LDIV-24-13

Land Division Conditions of Approval

- 1. Project Name:** Jamestown Quarry PP
- 2. Location:** 43.0171, -89.4819
- 3. Permit Request No.:** PP-2551-24
- 4. Resolution No.:** R-132-24
- 5. Decision Date:** June 18, 2024
- 6. Type of Action Requested:** Preliminary Plat Approval
- 7. Zoning District:** R-D PDD-GIP
- 8. Legal Description:** Metes and bounds

PRELIMINARY PLAT OF JAMESTOWN QUARRY

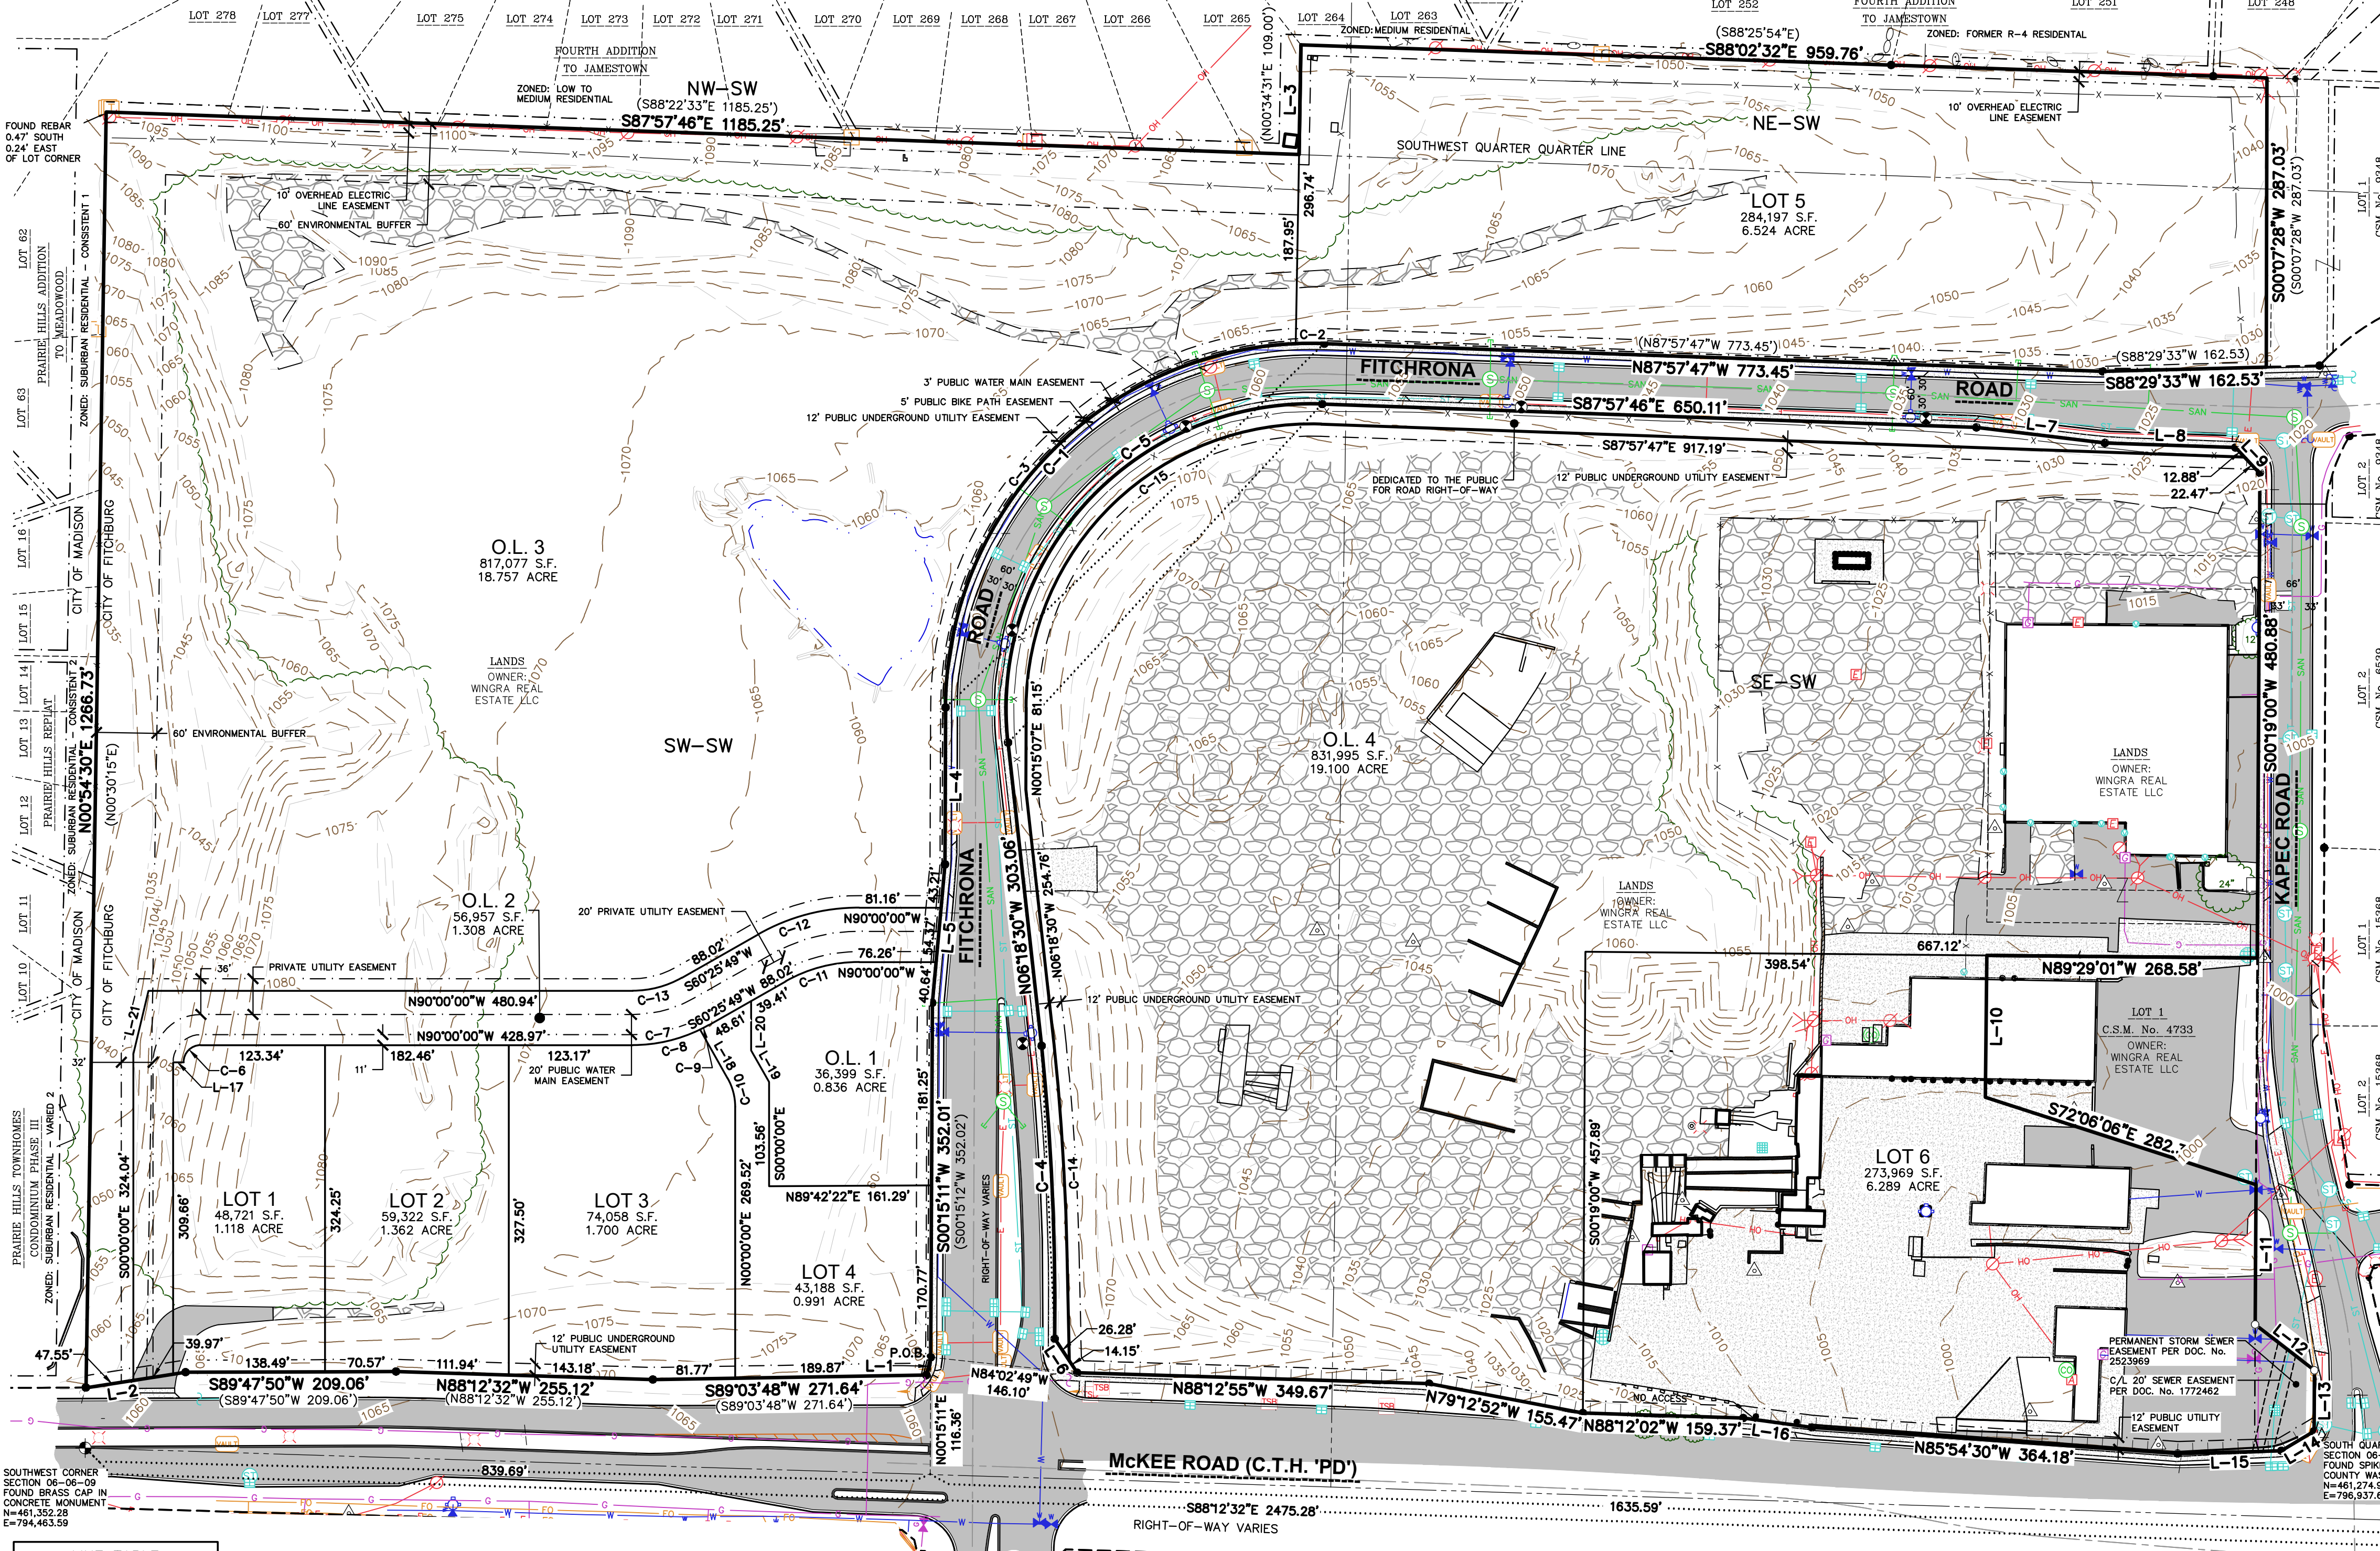
7. A note shall be added to the final plat regarding the structure crossing the property line of Lot 1 CSM 4733 stating that upon redevelopment, new structures shall comply with setback requirements in effect at the time of the proposed development. Not shall be add prior to the city signing the final plat.

8. All areas under control of the subdivider shall be included in the proposed Lot 4, excluding Lot 1 CSM 4733, is possible.
9. The purpose of each outlot shall be added to the preliminary plat, for example, stormwater or future development.

11. Concurrence from utilities (gas, electric, cable, phone) shall be provided with regards to the easement locations shown on the plat. An email or letter from the utilities is sufficient.

12. Given underground installation for electric and communications, a restriction shall be recorded with the final plat stating that the final grade shall not be altered by more than six (6) inches without written consent of the utilities involved.
